# Access Compliance Report

## Public Rights-of-Way

Intersection ID: 51443	Main Street: SHARON_RD	Cross Street: ASHLEY_PARK_LN	Location: SE
ADA ID: 81DD65F0DE71	Ramp Type: Perp	Initial Pass/Fail: Fail	Overall Compliance: No
Severity Score: 13.75			
Codes/Mitigation Info/Possible Solution		Field Measurements/Component Compliance

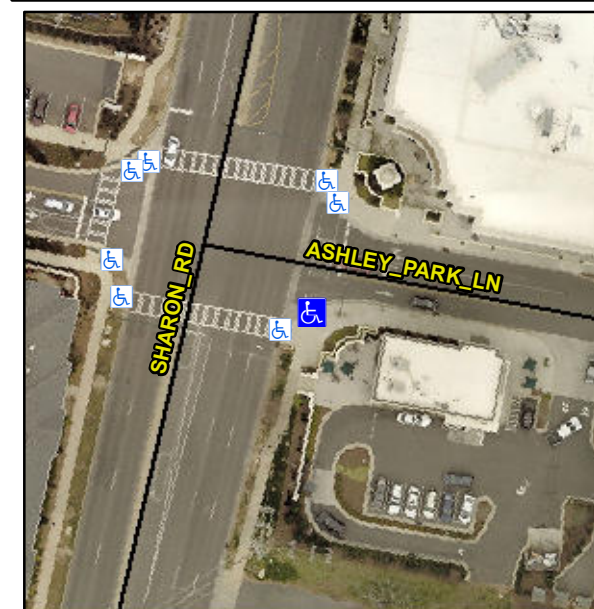
**R304.2.2, R304.5.3**

Compliance	Description	Data	Compliance	Description	Data
N/A	Ramp Length (in)	98.0	No	Ramp Slope (%)	9.1
Yes	Ramp Width (in)	48.0	No	Ramp XSlope (%)	2.8
N/A	Flare Type LT	N/A	N/A	Flare Type RT	N/A
N/A	Flare Slope LT (%)	N/A	N/A	Flare Slope RT (%)	N/A
N/A	Flare Traversable LT?	N/A	N/A	Flare Traversable RT?	N/A
N/A	Landing Length (in)	N/A	N/A	DWS Provided?	N/A
N/A	Landing Width (in)	N/A	N/A	DWS Contrast?	N/A
N/A	Landing Slope (%)	N/A	N/A	DWS Length (in)	N/A
N/A	Landing X Slope (%)	N/A	N/A	DWS Full Width?	N/A
N/A	Landing Curb? (Y/N)	N/A	N/A	DWS Offset (in)	N/A
N/A	Shared Landing?	N/A			
N/A	Gutter Ponding?	N/A	N/A	Gutter Slope (%)	N/A
N/A	Gutter Lip Ht (in)	N/A	N/A	Gutter X Slope (%)	N/A
N/A	Painted X Walk1?	Yes	N/A	Painted X Walk2?	N/A
	X Walk 1 Direction	To NE		X Walk 2 Direction	N/A
N/A	X Walk 1 Width (in)	104.0	N/A	X Walk 2 Width (in)	N/A
	X Walk 1 Slope (%)	2.6		X Walk 2 Slope (%)	N/A
	X Walk 1 X Slope (%)	2.6		X Walk 2 X Slope (%)	N/A

**Remove & Replace Entire Ramp.**
